NO.	DATE	DESCRIPTION
1	01/15/2020	ADDENDUM NO.1

VILLAGE OF OSWEGO, ILLINOIS

WATER SYSTEM IMPROVEMENTS WELLS NOS. 6 AND 8 ELECTRICAL REMODELING

WELL NO 6 DEMOLITION ONE-LINE DIAGRAM AND ELECTRICAL DETAILS

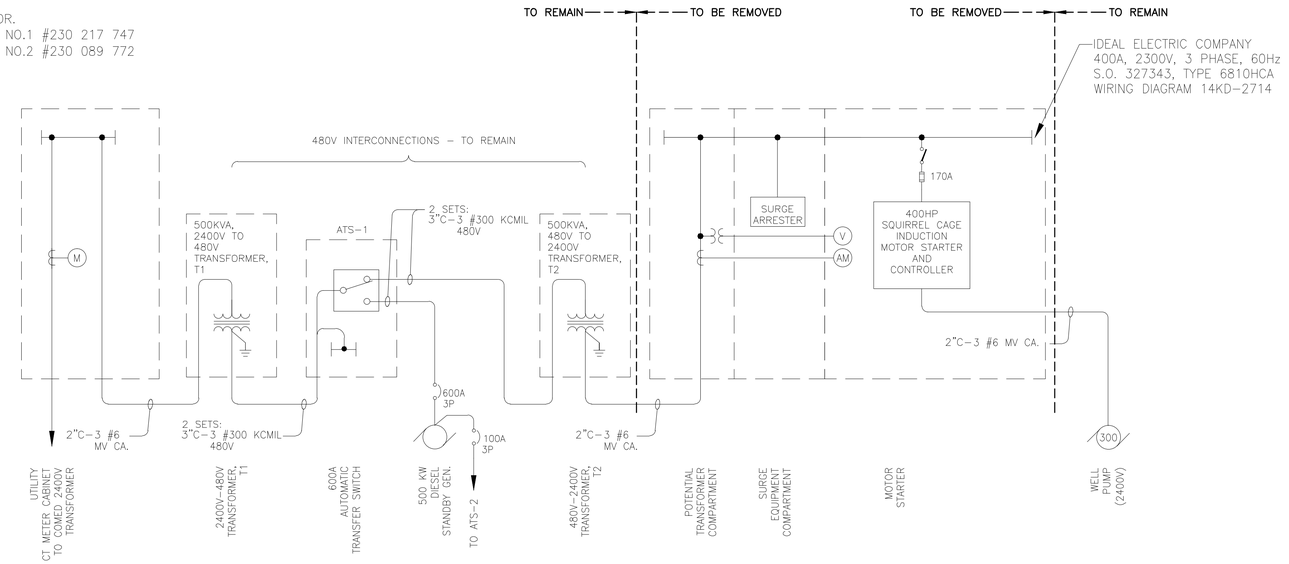
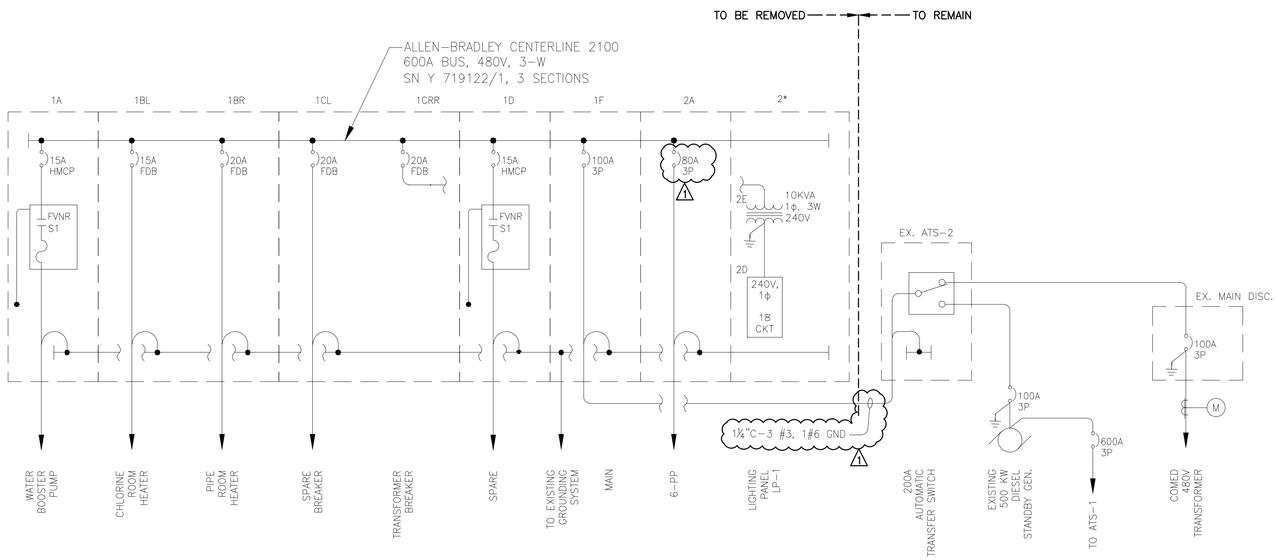
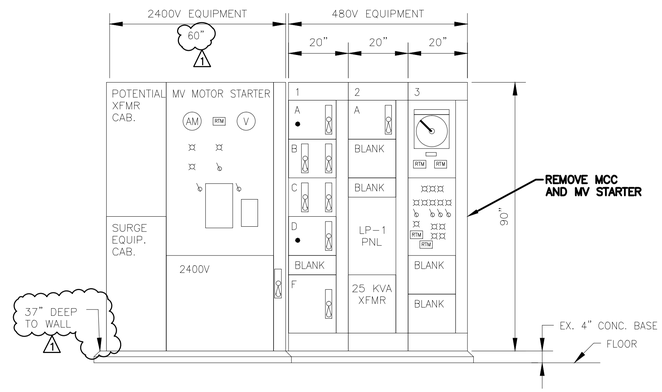
1. **EXISTING MOTOR CONTROL CENTER ONE-LINE WAS DOCUMENT AS-IS ON JULY 30, 2019. CONTRACTOR TO TAG ALL WIRING FOR RECONNECTION TO NEW MCC UNLESS NOTED OTHERWISE.**
2. **REMOVE EXISTING 2400V PT CABINET, SURGE EQUIPMENT DEVICE, AND MEDIUM VOLTAGE MOTOR STARTER CABINET. RETAIN EXISTING 2400V FEEDERS FOR NEW MEDIUM VOLTAGE SOFT STARTER REPLACEMENT.**
3. **REMOVE EXISTING 480V MCC AND PUMP CONTROLS. RETAIN EXISTING LOW VOLTAGE POWER UP TO 480V AND CONTROLS CONDUITS AND CABLES FOR RECONNECTION TO NEW MCC.**

WELL NO 6 PROPOSED ONE-LINE DIAGRAM AND ELECTRICAL DETAILS

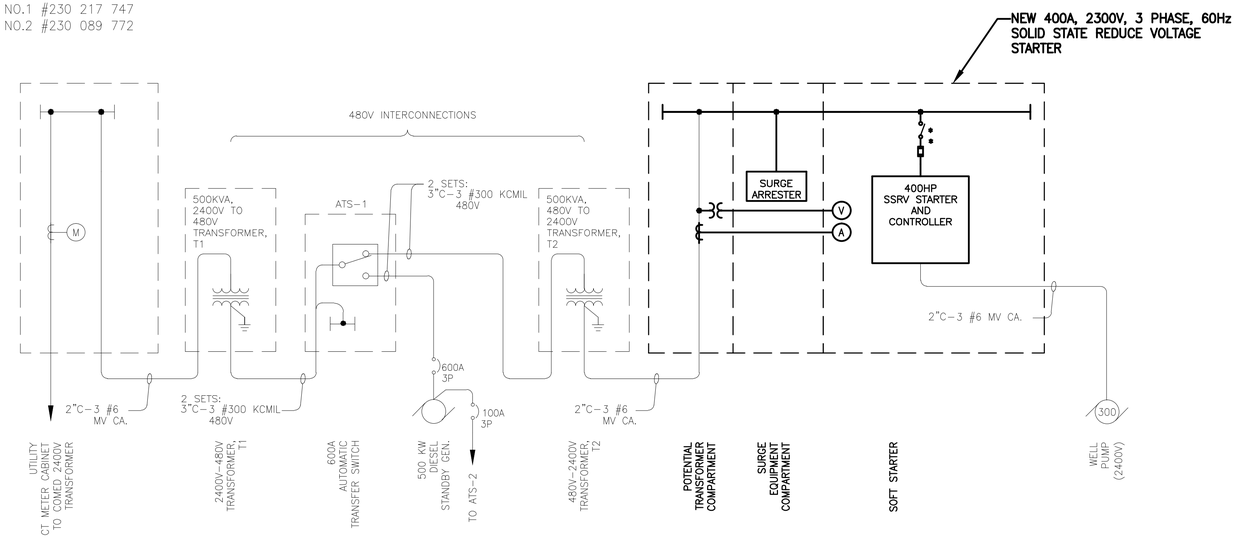
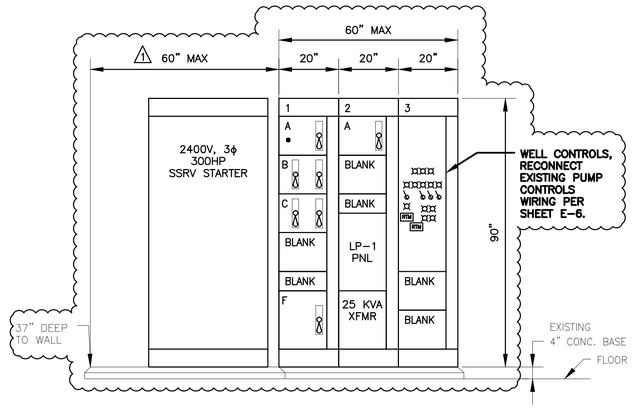
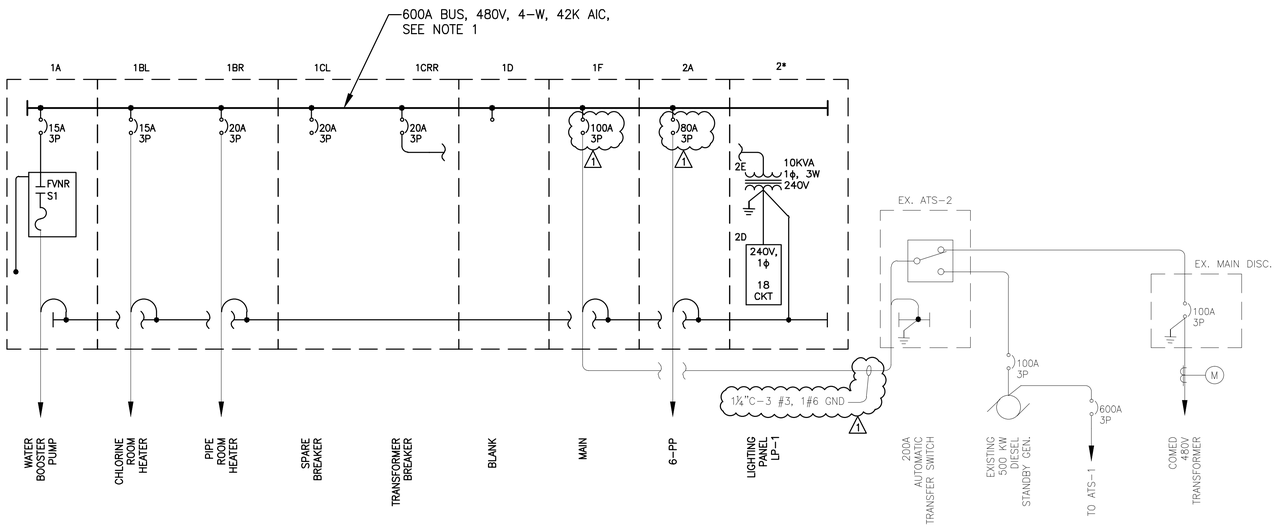
3A. "WELL CONTROL PANEL" – SEE NOTE 2

1. PROVIDE 200A MAIN BREAKER, 480V, 3-PHASE, 4-WIRE MCC TO REPLACE EXISTING MCC LAYOUT. NEW MCC MUST NOT EXCEED EXISTING DIMENSIONS.
2. CONTRACTOR TO RECONNECT EXISTING POWER AND CONTROLS FROM EXISTING EQUIPMENT UNLESS NOTED OTHERWISE.
   A. COORDINATE WITH VILLAGE INTEGRATOR TO UPGRADE EXISTING SCADA PANEL OIT TO MINIMUM 9" WIDE OIT.
3. PROVIDE NEW 2400V SOFT STARTER WITH SURGE PROTECTION, CT/PT, H-O-A, AND MOTOR PROTECTION TO REPLACE EXISTING MV MOTOR STARTER.
4. PROVIDE 3/4"C-(1) E-NET CA. FROM NEW SOFT STARTER TO EXISTING SCADA PANEL.

WELL NO 8 DEMOLITION ONE-LINE DIAGRAM AND ELECTRICAL DETAILS

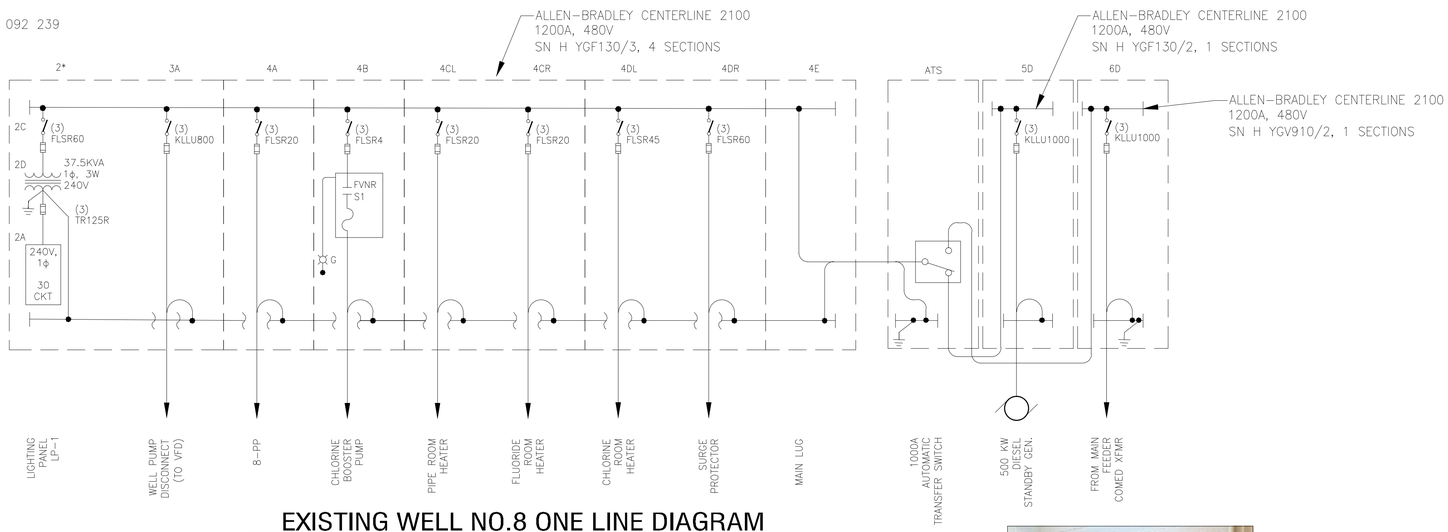
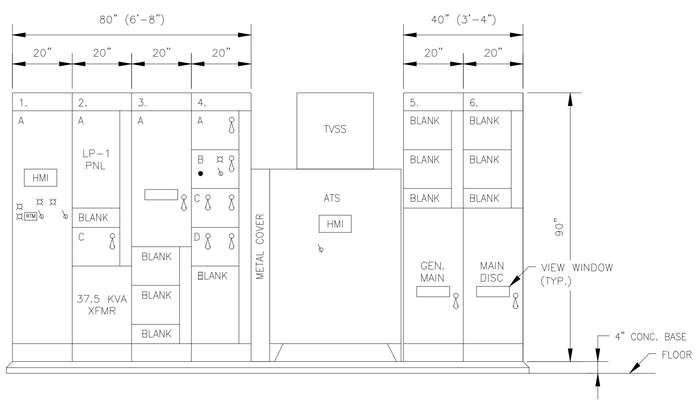
1. EXISTING MOTOR CONTROL CENTER ONE-LINE WAS DOCUMENT AS-IS ON JULY 30, 2019.
2. REMOVE AND REPLACE EXISTING 480V VFD ASSEMBLY AND STEP-UP TRANSFORMER.
   A. PROTECT EXISTING FEEDERS AND CONTROLS WIRING FOR RECONNECTION TO NEW VFD ASSEMBLY AND NEW STEP-UP TRANSFORMER.
   B. FLUSH CUT AND CAP ABANDONED CONDUIT AND WIRING BY STEP-UP TRANSFORMER.
3. REMOVED.

WELL NO 8 PROPOSED ONE-LINE DIAGRAM AND ELECTRICAL DETAILS

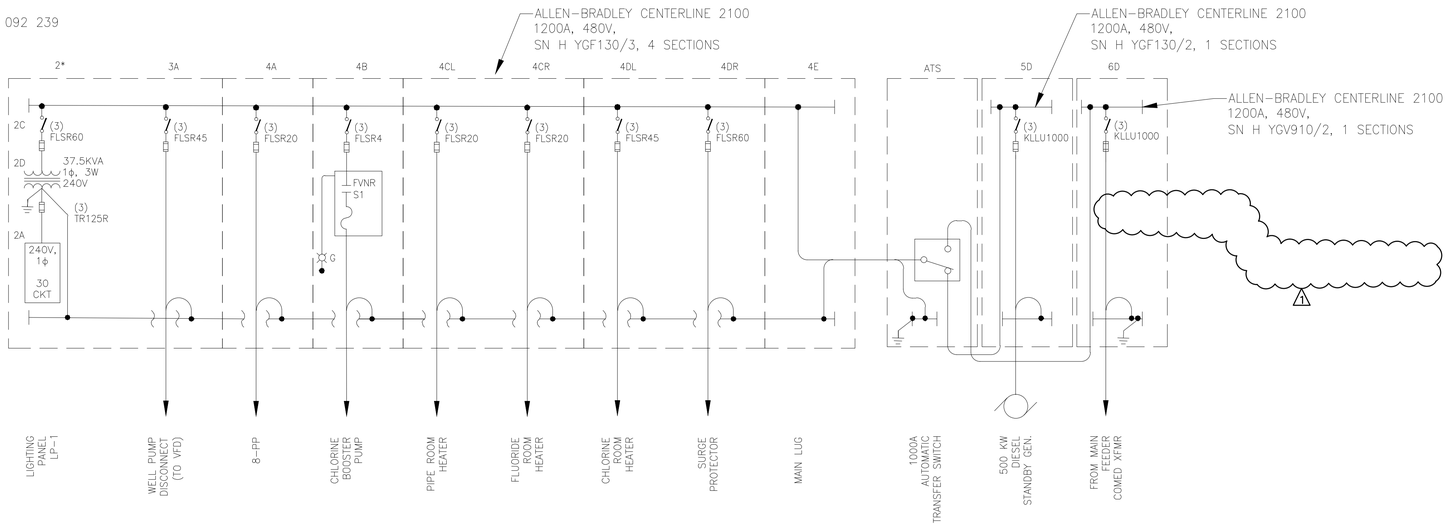
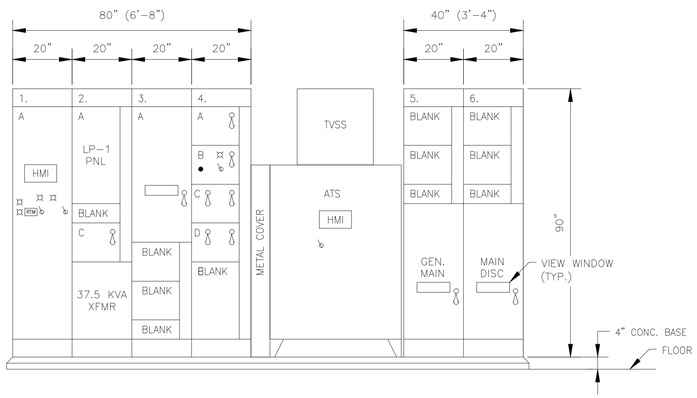
1. EXISTING MOTOR CONTROL CENTER ONE-LINE WAS DOCUMENT AS-IS ON JULY 30, 2019.
2. PROVIDE VFD ASSEMBLY TO REPLACE EXISTING VFD ASSEMBLY FOR 350HP DEEP WELL PUMP. NEW ASSEMBLY MUST NOT EXCEED ORIGINAL WIDTH OF 90"W X 30"D WITHOUT APPROVAL OF ENGINEER AND OWNER.
   A. VFD WITH FILTER, LINE REACTOR, AS NEEDED TO LOWER HARMONICS.
   B. SINE WAVE FILTER OUTPUT TO BE SIZE WITH STEP-UP TRANSFORMER.
3. PROVIDE A 500KVA, 480V TO 2400V, OIL-FILL, 3-PHASE DRIVE ISOLATION STEP-UP SOLOMAN TRANSFORMER OR EQUAL TO FEED EXISTING 350 HP DEEP WELL PUMP. MODIFY OR REPLACE EXISTING EQUIPMENT PAD AS REQUIRED.
4. REMOVED. 1

MOTOR CONTROL CIRCUIT SCHEMATIC DIAGRAMS

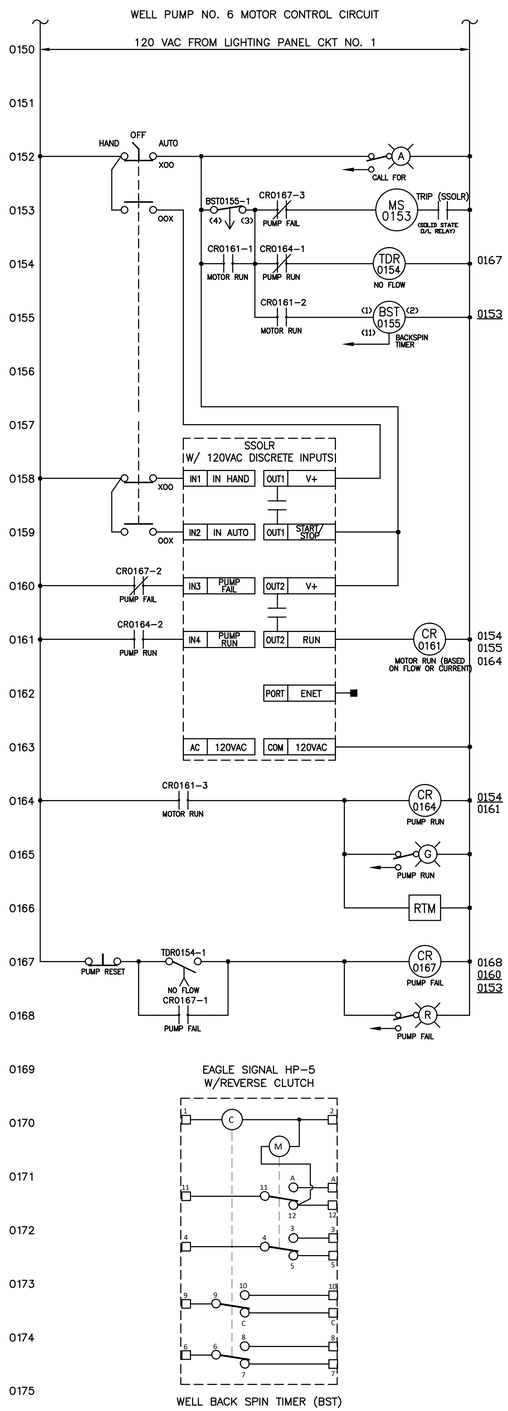
1. CONTRACTOR TO COORDINATE WITH VILLAGE INTEGRATOR FOR THE FOLLOWING CHANGES TO THE WELL PUMP CONTROLS FOR THE NEW 480V MCC.

A. ELIMINATE THE FLOW CHART, WELL PRESSURE INDICATOR AND WELL PUMP START AND STOP COUNTERS IN THE MCC. PROVIDE ALL SWITCHES, PUSHBUTTONS AND INDICATORS TO MATCH EXISTING UNLESS NOTED OTHERWISE BELOW.

B. WELL "FAIL TO RUN" TO BE IMPLEMENTED IN THE PLC.
      i. RETAIN THE "SYSTEM FAIL" AND "PRESSURE ALARM" INDICATORS ON THE MCC.
      ii. STOPS THE CALL FOR THE PUMP IN SCADA
      iii. ALARM TO BE ADDED TO SCADA.

C. WELL PUMP HOA HAND RUNS THE WELL NO MATTER WHAT, EXCEPT OVERLOAD.

D. SHORT CYCLE (BACKSPIN) STAYS IN THE MCC WE
      i. CHANGE NAME TO "BACKSPIN"

E. PROVIDE "WELL PUMP OVERLOAD" DRY CONTACTS

F. THE BYPASS (PURGE) VALVE LOGIC STAYS IN THE MCC
      i. VALVE TO CLOSE DELAY (PRESERVE EXISTING)
      ii. PUMP STOP DELAY ON VALVE OPEN (PRESERVE EXISTING)

G. BYPASS (PURGE) VALVE POSITION INDICATION, FAULT LOGIC AND FAULT INDICATION GOES TO THE OIT.
      i. ALARMS TO BE ADDED TO SCADA
      ii. VALVE OPEN FAIL ALARM TO THE PLC STOPS THE WELL PUMP CALL (PUMP MAY CONTINUE TO RUN ON SWITCH FAIL AS BEFORE).
      iii. VALVE CLOSE FAIL ALARM IN THE PLC STOPS THE WELL PUMP CALL.
      iv. PROVIDE DRY CONTACTS FOR "OPEN" AND "CLOSED" STATUS.
      v. ELIMINATE THE 4 BYPASS VALVE INDICATORS ON THE MCC.

H. THE WELL SHOULD NOT START IF THE BYPASS (PURGE) VALVE "CLOSED" LIMIT SWITCH CHANGES STATE UNEXPECTEDLY OR FAILS.

I. CHEMICAL PUMPS RUN BY MINIMUM FLOW DETECED IN THE PLC, IN ADDITION TO RELAY CONTACTS TIED TO THE "RUN" SIGNAL FROM THE WELL PUMP STARTER.

J. RENAME "IRON CONTROL PUMP" LABEL TO "PHOSPHATE CONTROL PUMP" AT MCC.

2. INTEGRATOR TO PROVIDE ADDITIONAL CONTROL WIRES BETWEEN THE PANELS TO PICK UP ADDITIONAL PURGE VALVE STATE AND WELL PUMP OVERLOAD.
